# King Township Planning Criteria For Established Neighbourhoods

By John Hollick, P.Eng.

# Snowberry Lots

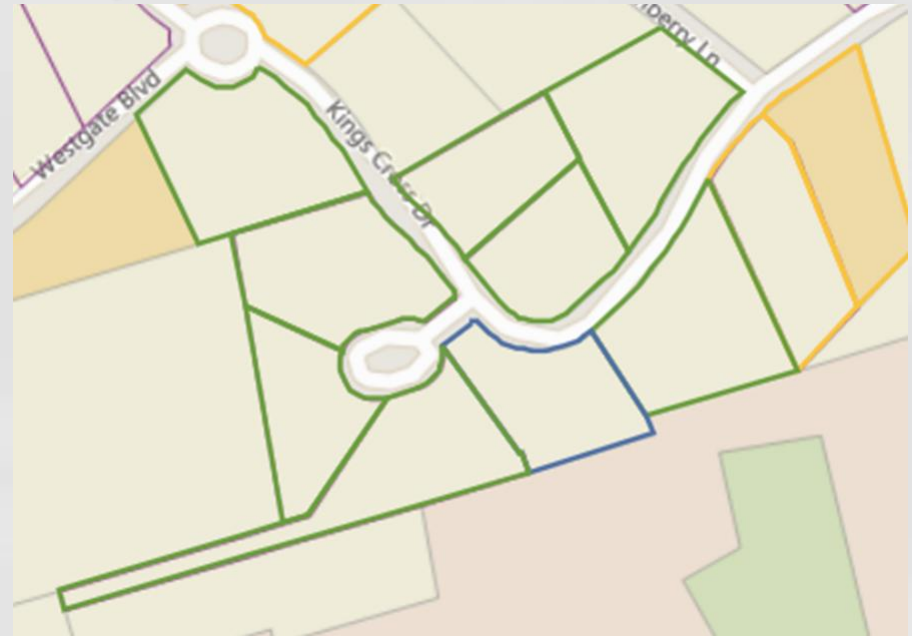
22 & 32 Snowberry are smaller than 2 & 12 Snowberry  
Adjusting boundaries on 22 & 32 to create three lots was approved by OMB but with restrictions

Combined area of 2 & 12 Snowberry is  $2.26 + 2.88 = 5.14$  acres

Combined area of 22 & 32 Snowberry is  $2.5 + 2.59 = 5.09$  acres

# Existing Neighbourhood Area

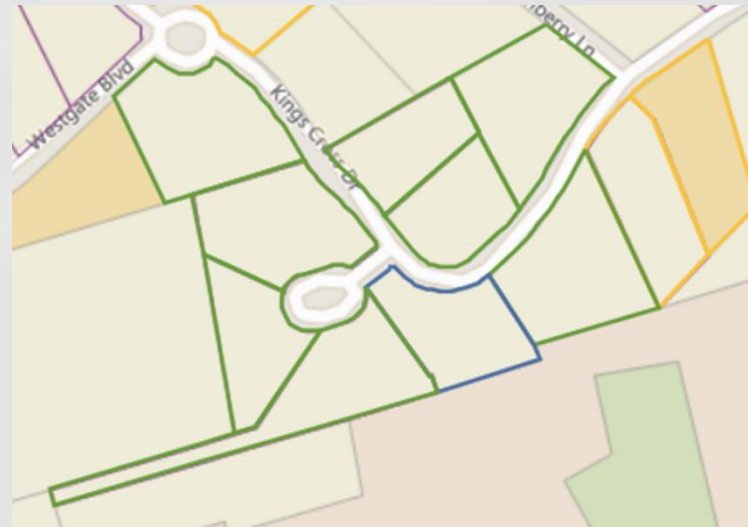
- Applicant Study Area included dozens of lots in Kingscross not visible from new lot and not considered to be comparable

- Planning Dept guidelines state **Study Area is to be visible from the new lot**

# Trees along Kingscross to disappear

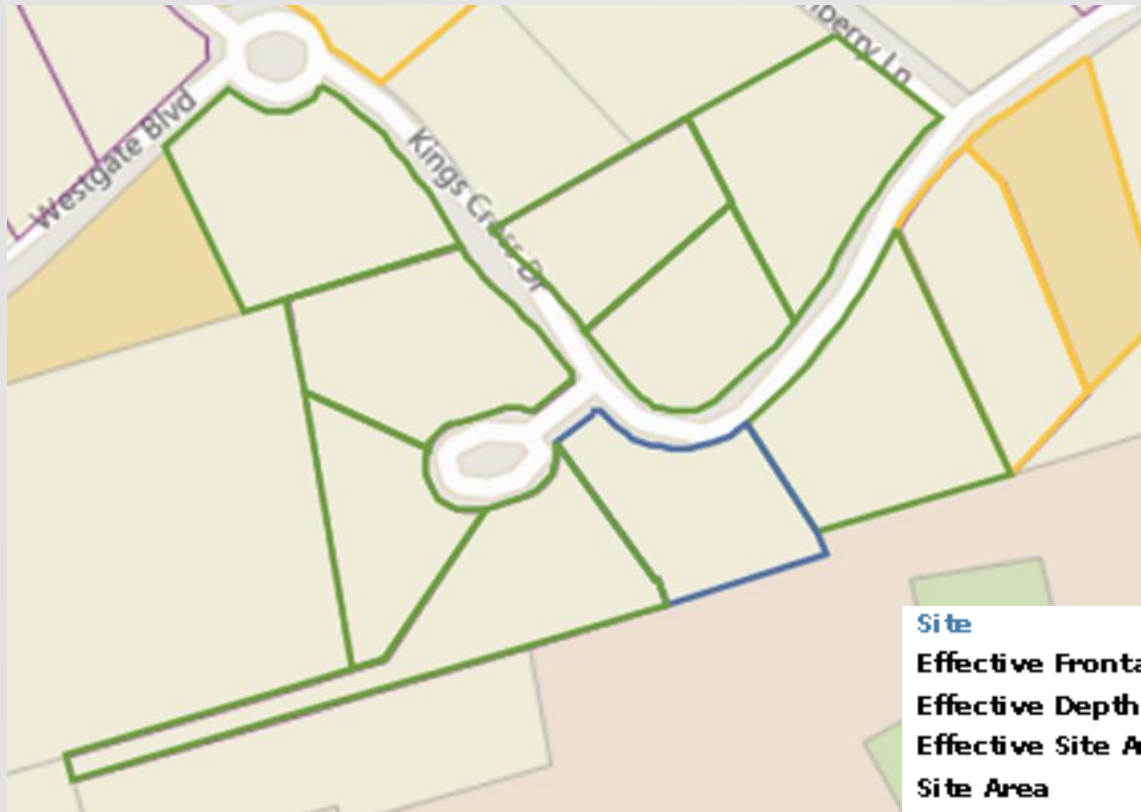
**Destroy 35  
mature  
trees  
(shown in  
as red dots)**

Corner of house marked by a tree and 15 feet from Kingscross Dr boundary
